Concession Layout for 861 v6

Card Combinations

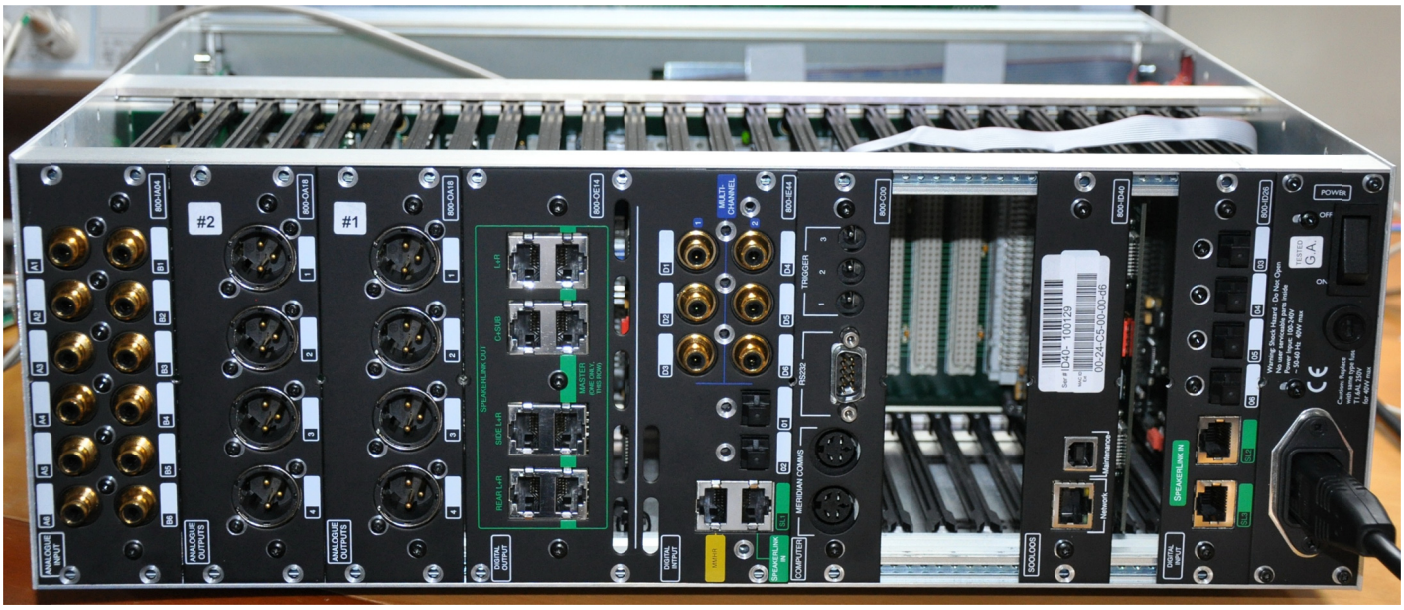
To cope with Z8 bus motherboard tolerance issues C00 is moved to a more central location, as described here. An 861 with additional 2x OA18 plus ID26 and ID40 is shown in the photograph above.

The essential change is changing locations for C00, ID26 and IA04 #2.

- DSP EF in socket J23
- C00: in socket J17
- IE44: In socket J15
- DSP CD: In socket J12
- OE14: In socket J11
- IA04: In socket J2
- No terminators.

- ID26: Should be fitted in J25
- ID40: In socket J22
- IA04 #2: J20
- OA18: Fit in locations J5 and J8
- OA08 Fit in locations J6 and J8
- No terminators.
